PD Modification Application: PRS 23-0744

REVISED REPORT

AGENCY REVIEW COMMENT SHEET

PETITION NO: PRS 23-0744

2.5 Proposed Site Plan (partial provided below for size and orientation purposes. See Section 8.2 for full site plan)

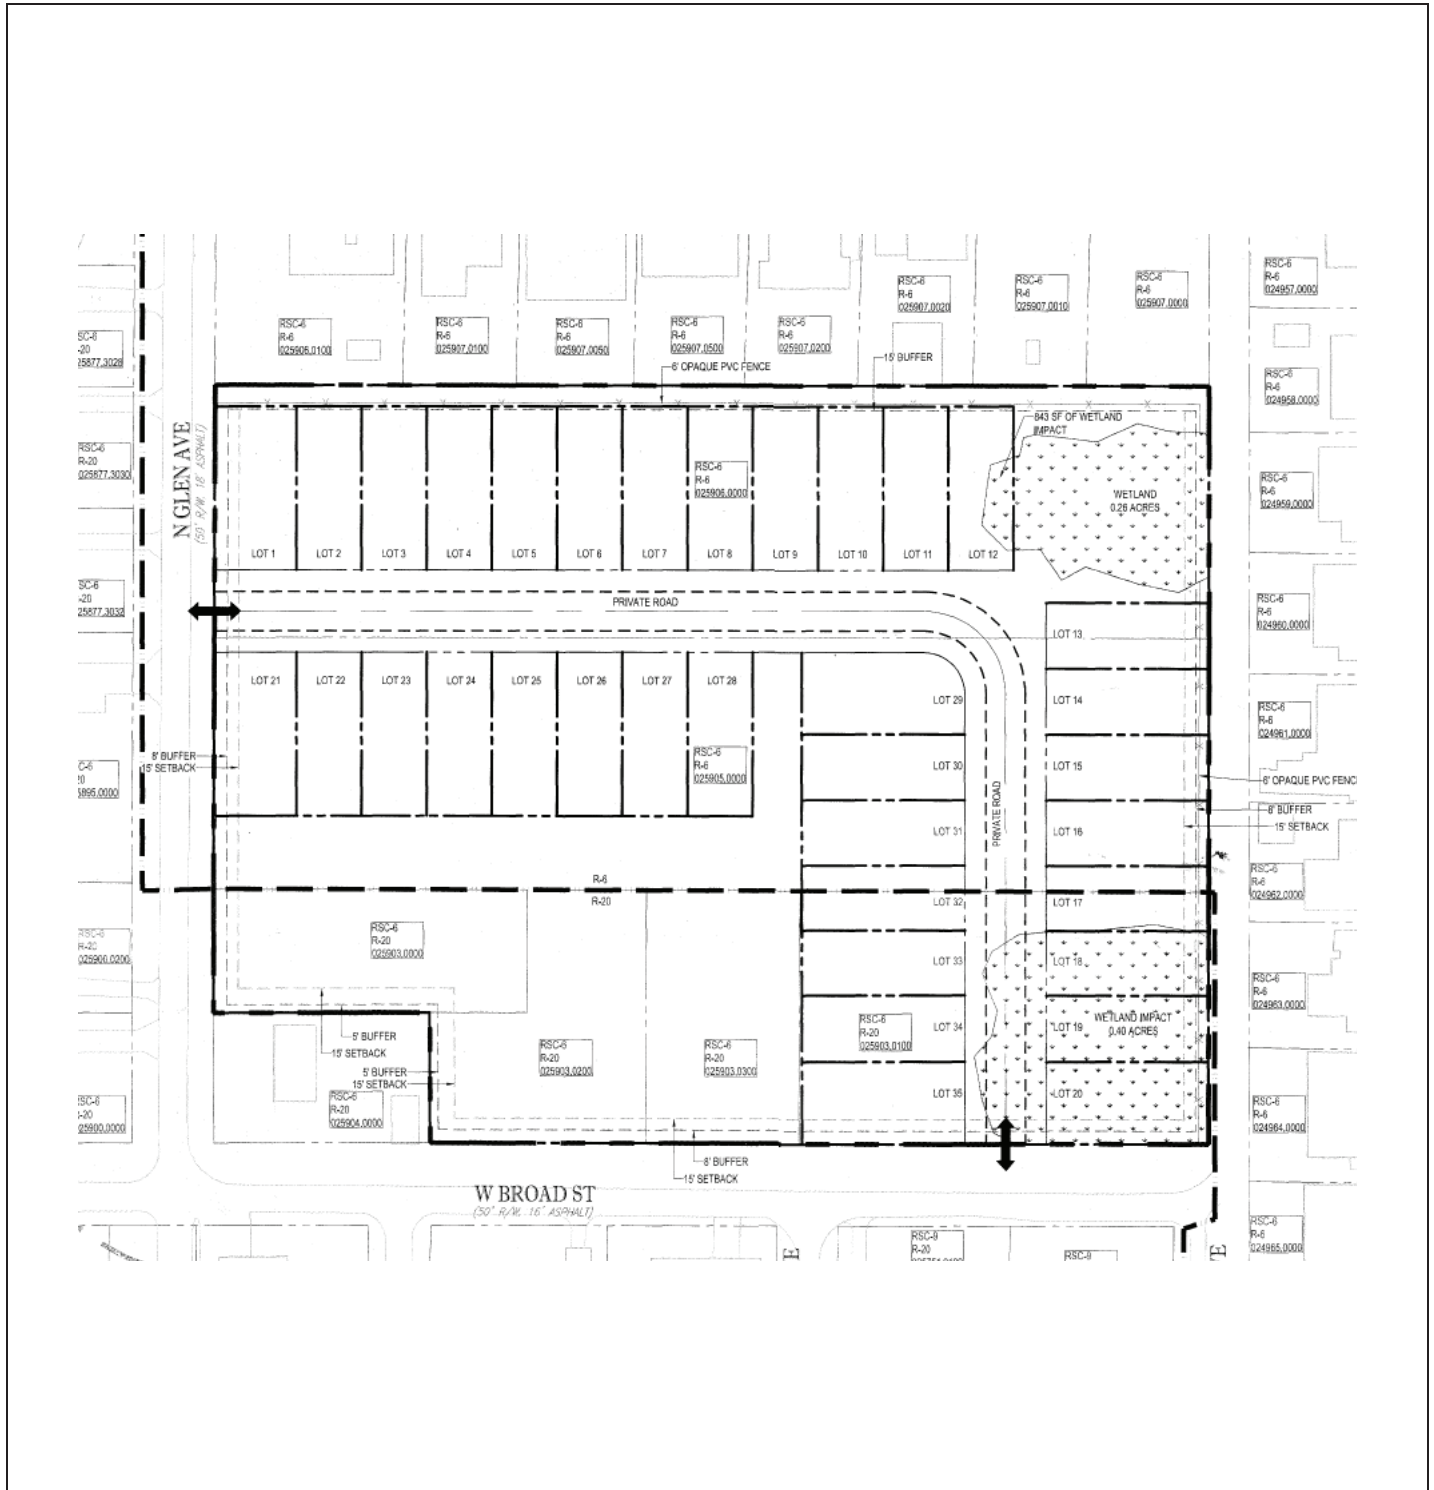
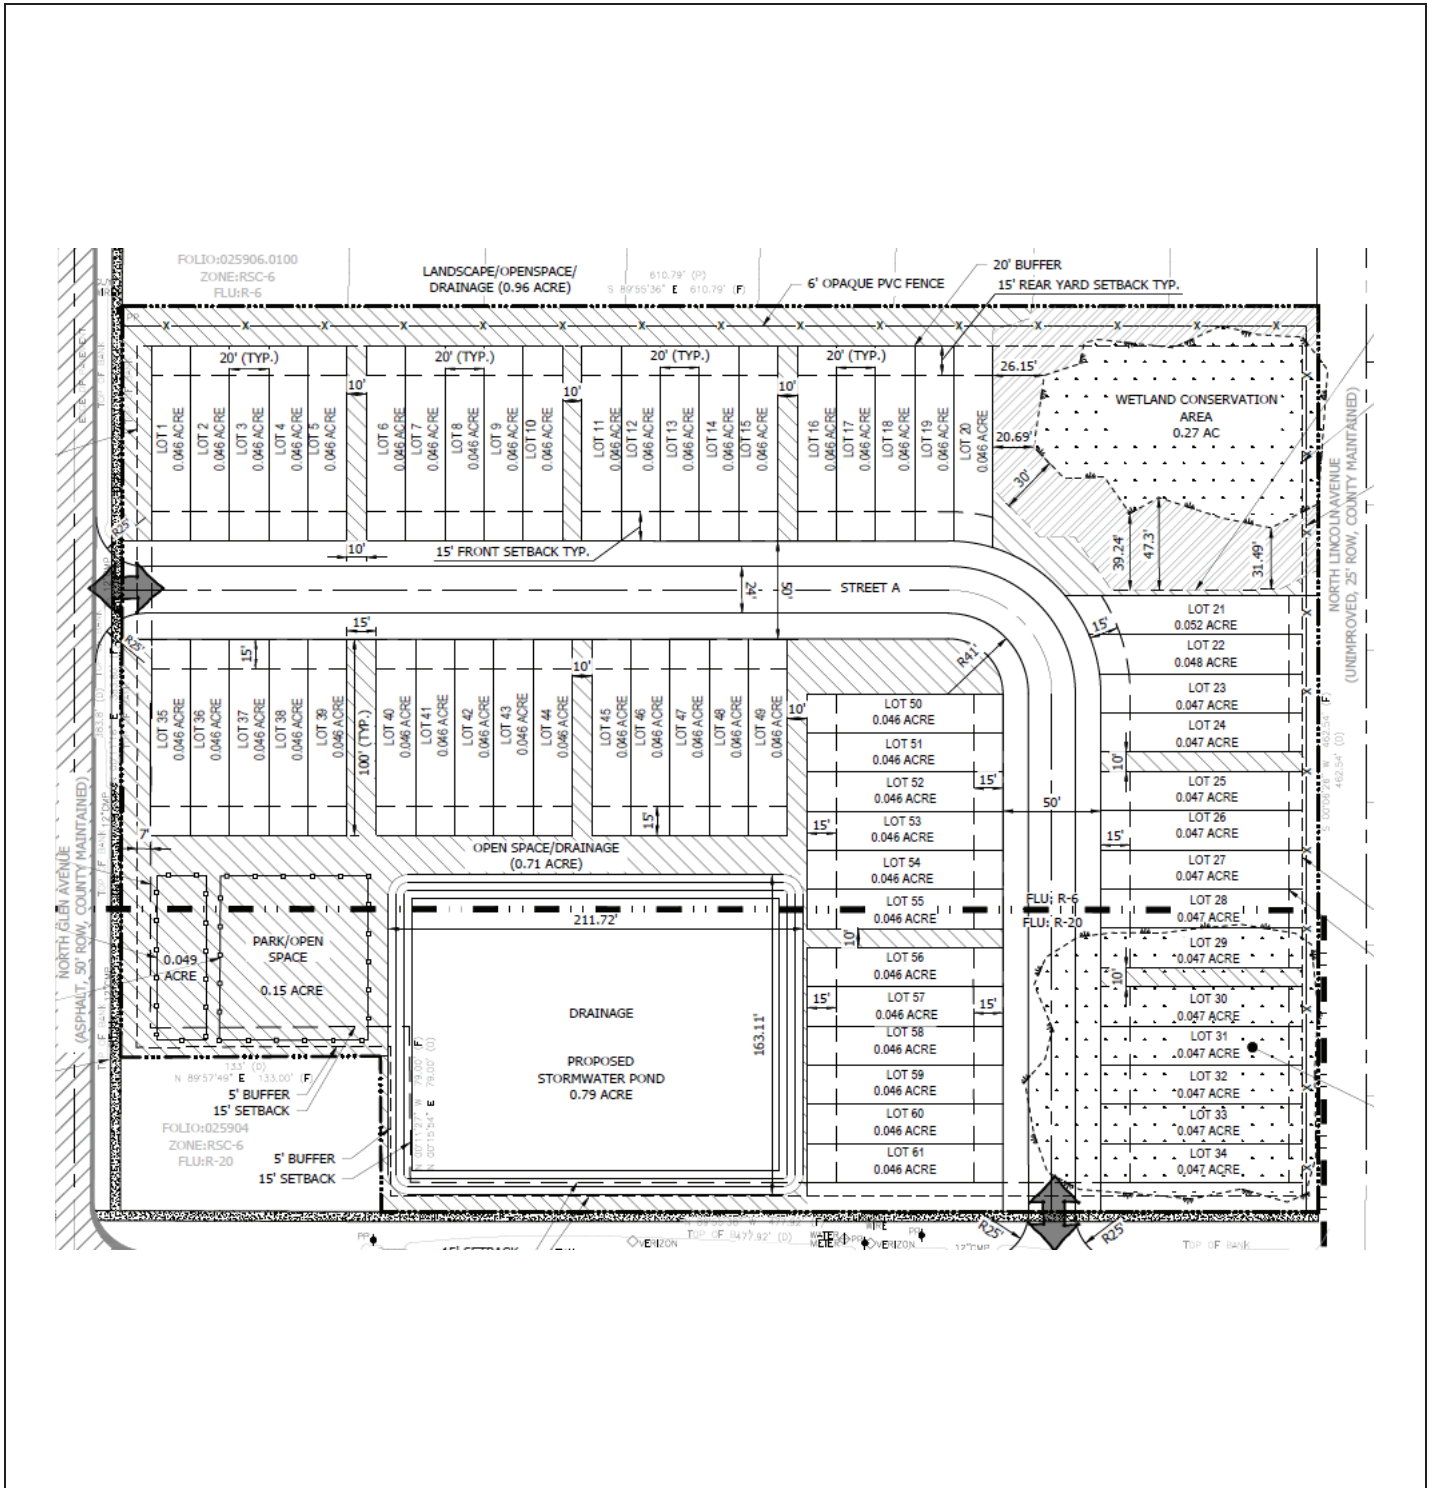
PD 18-0943, as most recently modified by MM 20-0368 was approved in 2020 to allow for 61 attached (townhomes) conventional residential units. The applicant requests to modify the PD to remove the restrictions for emergency gated access to W. Broad St., which if approved would mean the project will be served by two full access connections (one to W. Broad St. and one to N. Glen Ave.). No change in project entitlements is proposed.

The project will be served by two full access connections
(one to W. Broad St. and one to N. Glen Ave.)

4. The project shall construct one (1) vehicular and pedestrian access driveway onto N. Glen Ave. and one (1) vehicular and pedestrian access driveway onto W. Broad St. ~~The access connection to W. Broad St. shall be an emergency access and gated with a Knox box (or other method of restricting non-emergency traffic acceptable to Hillsborough County).~~

6. If PRS 23-0744 is approved, the County Engineer will approve a Design Exception (dated September 21, 2023) which was found approvable on (September 22, 2023) for the W. Broad St. substandard roadway improvements. As W. Broad St. is a substandard local roadway, the developer will be required to make certain improvements to W. Broad St. (as specified below) concurrent with the initial increment of development, consistent with the Design Exception. Specifically, the developer shall:

- Widen W. Broad St. (between the project access and Glen Ave.) such that there is 20 feet of pavement.
 - Construct on both sides of W. Broad St. (between the project access and Glen Ave.) 6-foot stabilized shoulders.

Figure 3 – Currently Proposed Modification to Hillsborough County TTM TS-7

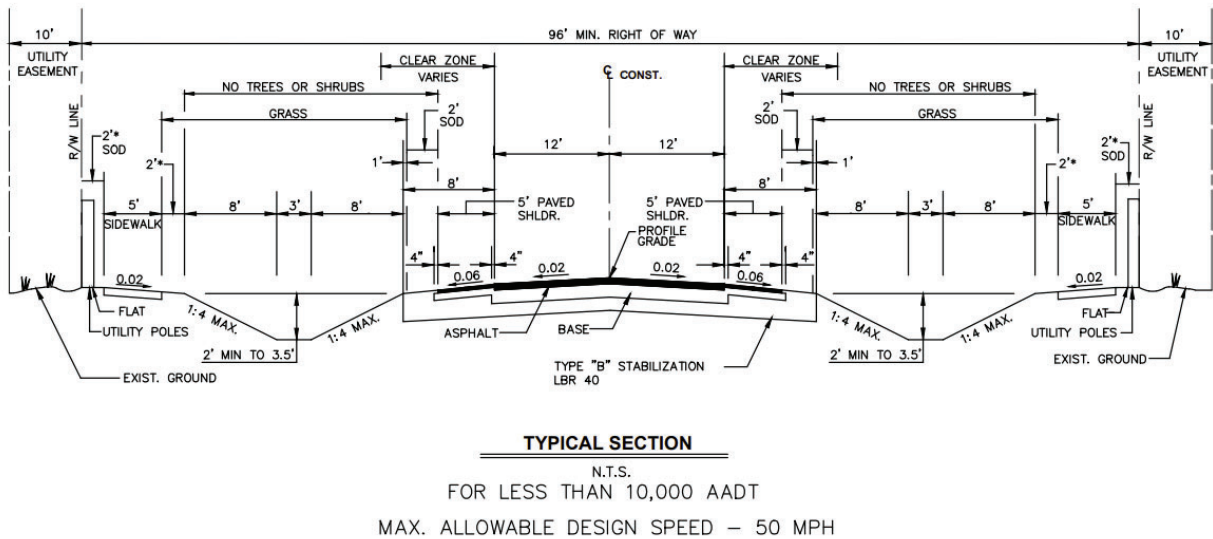
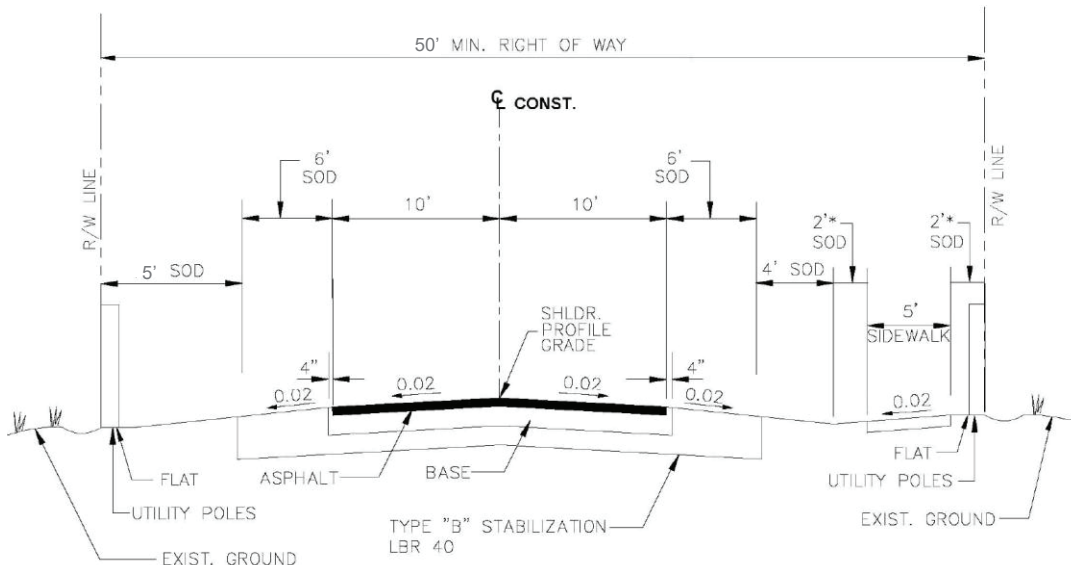
1. Based upon recently obtained survey along this segment, right of way varies on W Broad St, with a minimum width of 50 ft. TS-7 requires 96 feet with 12-foot travel lanes, 8-foot shoulders, 5-foot sidewalk and open drainage. There are existing 9-foot travel lanes, no paved shoulders, open drainage and no sidewalks.
2. The request is to provide 10-foot travel lanes on W Broad St from the project entrance to N Glen Ave. Based on section 3.1.1 of the Transportation Technical Manual, 10 feet is

the minimum lane width for local residential roads. Furthermore, the FDOT Florida Greenbook, Section 3-62, Table 3 identifies the minimum lane width for local urban roads as 10 feet, however, notes that 9-foot lane widths may be used in residential areas where right of way is limited.

3. The request is to provide 6-foot stabilized shoulders in lieu of the 8-foot shoulders.
4. Reduce the width of the open drainage, as shown in Figure 2.
5. A 5-foot sidewalk will be provided on one side of W Broad St across the property's frontage and extending across Folio 25904.0000 to N Himes Ave.

Figure 3 – Currently Proposed Modification to Hillsborough County TTM TS-7

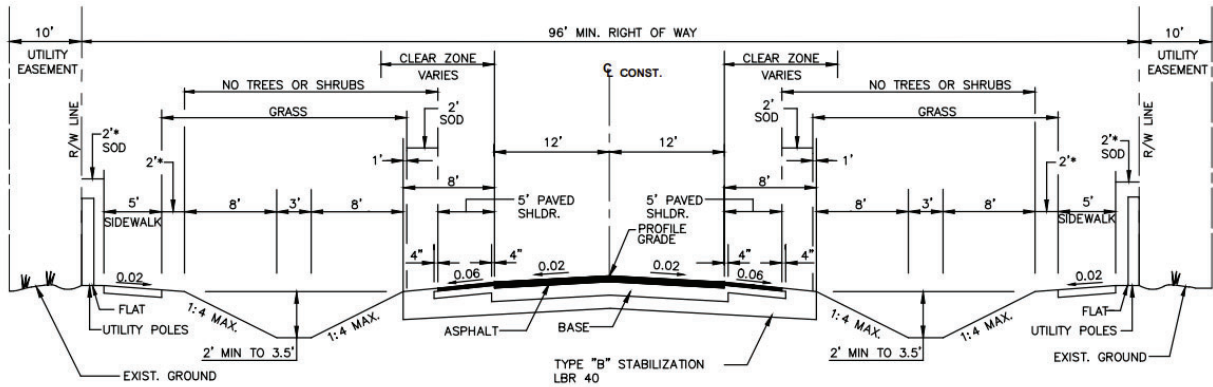
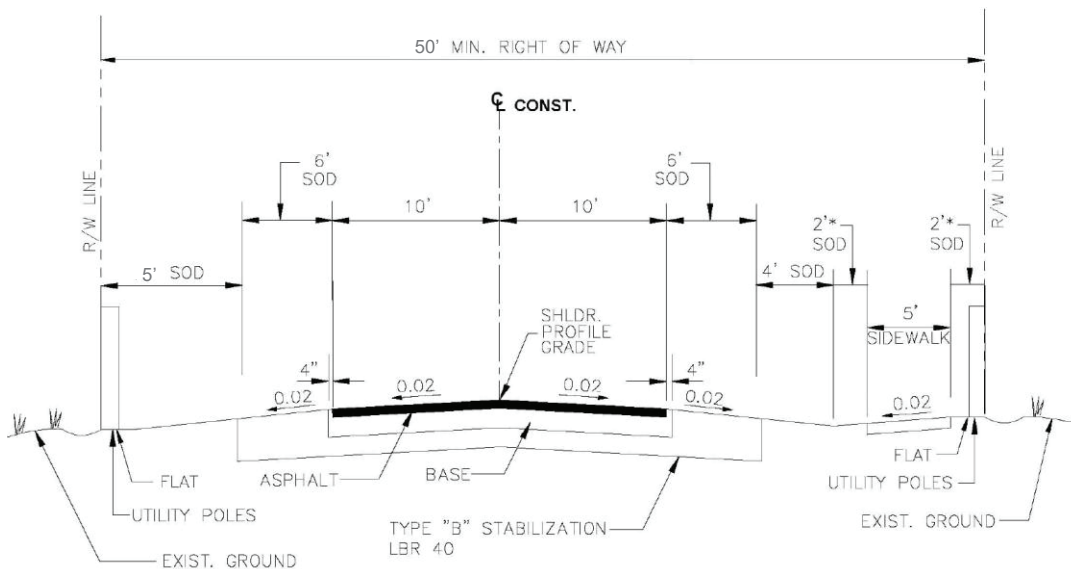
1. Based upon recently obtained survey along this segment, there is 50 feet of right of way available on N. Glen Avenue. TS-7 requires 96 feet with 12-foot travel lanes, 8-foot shoulders, 5-foot sidewalk and open drainage. There are existing 9-foot travel lanes, no paved shoulders, open drainage and no sidewalks.
2. The request is to provide 10-foot travel lanes from W. Kirby Street south along N Glen Avenue to W Broad Street. Based on section 3.1.1 of the Transportation Technical Manual, 10 feet is the minimum lane width for local residential roads. Furthermore, the FDOT Florida Greenbook, Section 3-62, Table 3 identifies the minimum lane width for

3. The request is to provide 6-foot stabilized shoulders in lieu of the 8-foot shoulders.
4. Reduce the width of the open drainage, as shown in Figure 2. The open drainage on the east side of N. Glen Avenue is proposed to remain unchanged.
5. A 5-foot sidewalk will be provided on the east side of N Glen Avenue from W Kirby Street to W Broad Street.

Figure 2 – Proposed Modification to Hillsborough County TTM TS-7

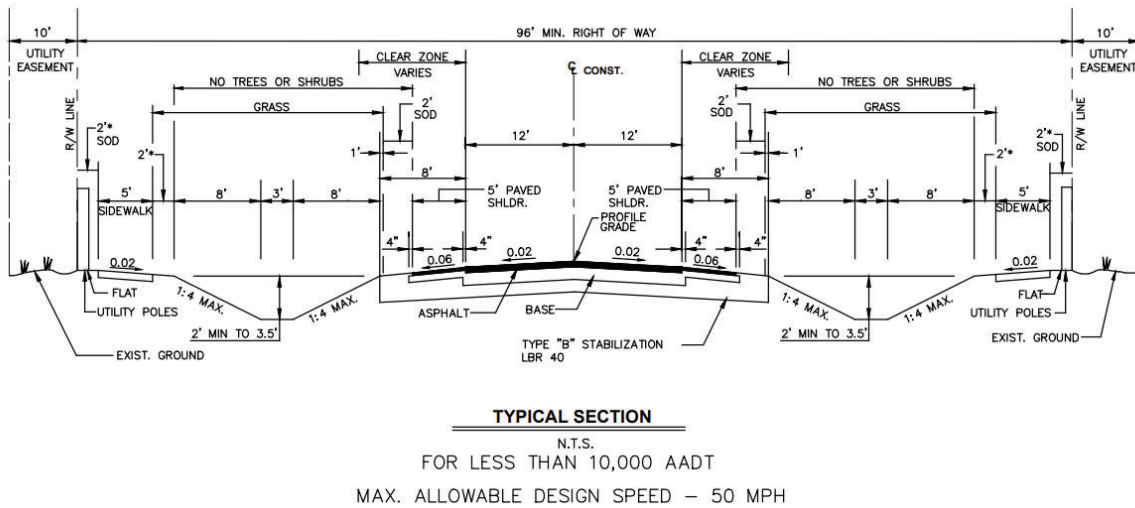
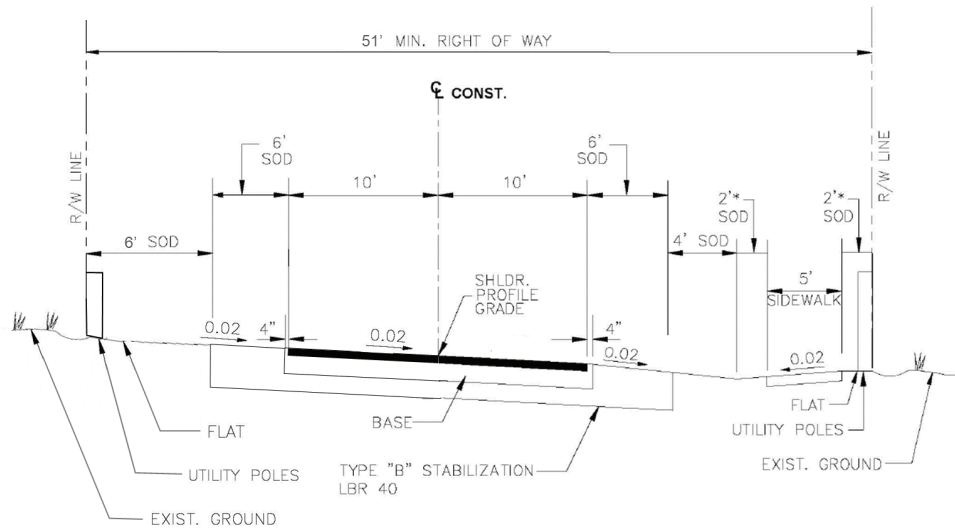
1. W Broad St has approximately 44 feet of ROW according to the Hillsborough County Right of Way Inventory. Surveyed information indicates Broad Street has 52 feet +/- of ROW which is still less than the required 96 feet. This is the main reason for the modification to TS 7. There is not enough room for all the TS 7 improvements. Due to the private property on the west end of this W Broad St segment (at N Glen Ave), the proposed section must be within the existing right of way.

Figure 3 – Currently Proposed Modification to Hillsborough County TTM TS-7

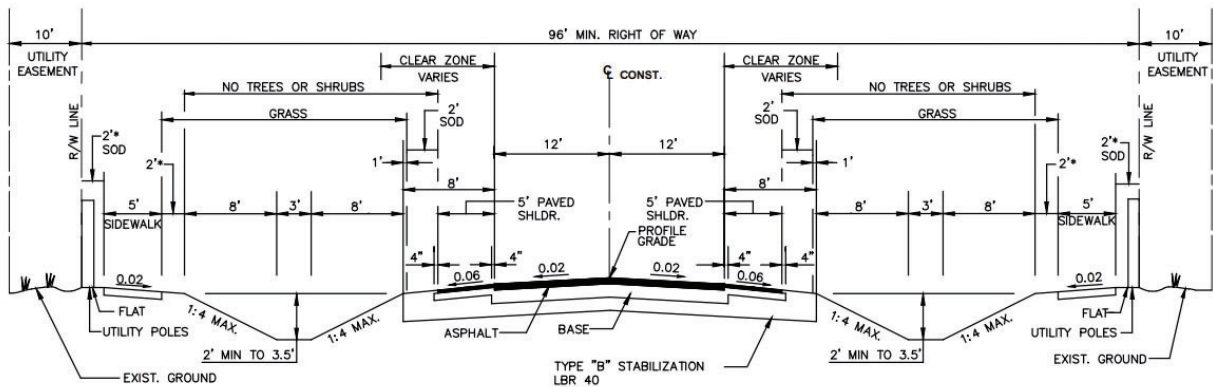
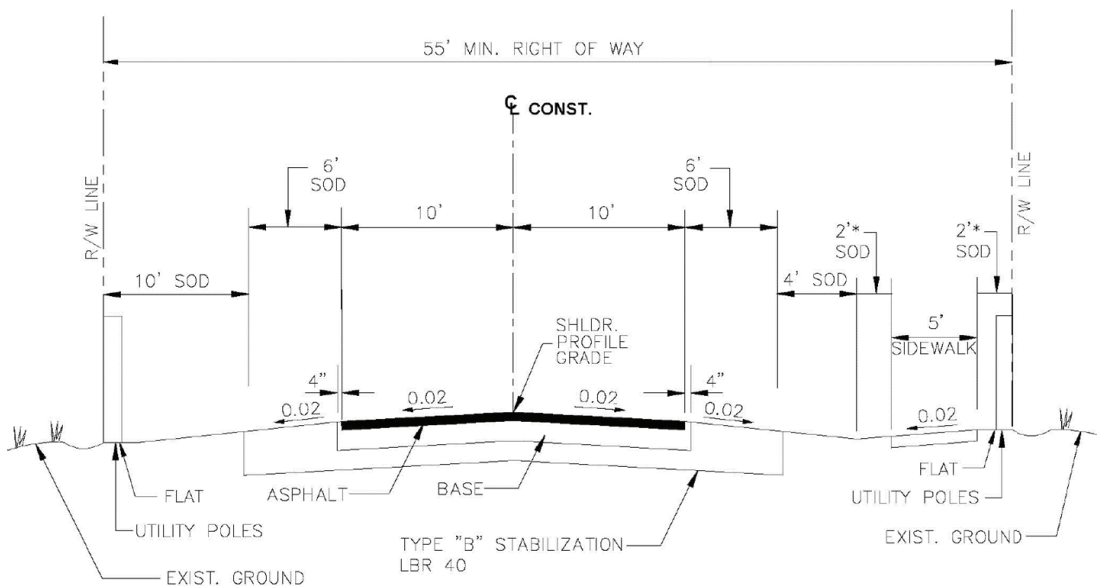
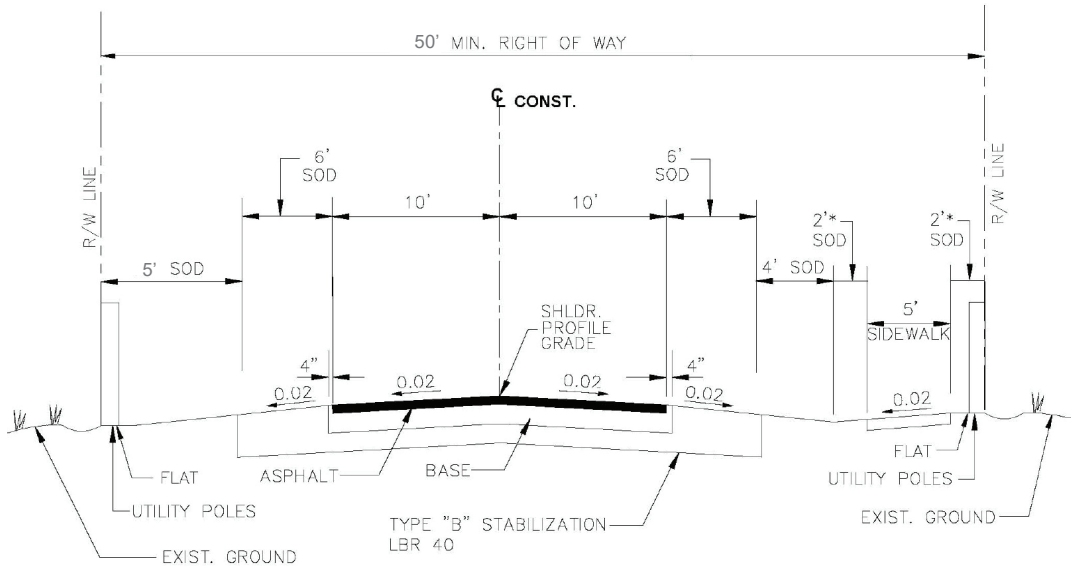
In this modification, we are proposing to reduce the width of the previously approved typical section for N Glen Ave from 55 feet to 50 feet. A new survey received on 06.20.2023 showed 50 feet of right of way available along N Glen Ave. Only portions of the right of way in which improvements will be required are controlled by the applicant; the proposed section must therefore be reduced in order to accommodate the improvements within the existing right of way. This Design Exception requests approval to make this reduction by reducing the 10 feet of

sod previously proposed on the west side of the road (Figure 2) to 5 feet (Figure 3). This Design Exception also proposes to apply this typical section from W Kirby St to W Broad St to accommodate new project trips going to W Broad St which is now being proposed as a full access. A separate Design Exception has been prepared for W Broad St. It should be noted that there is a private property on the northeast corner of the N Glen Ave and W Broad St intersection (southwest of the development) that cannot be modified as a part of the proposed improvements. No other modifications would be made to the typical section and there are no changes to the previously presented justifications. The previously approved exception is attached to this letter.
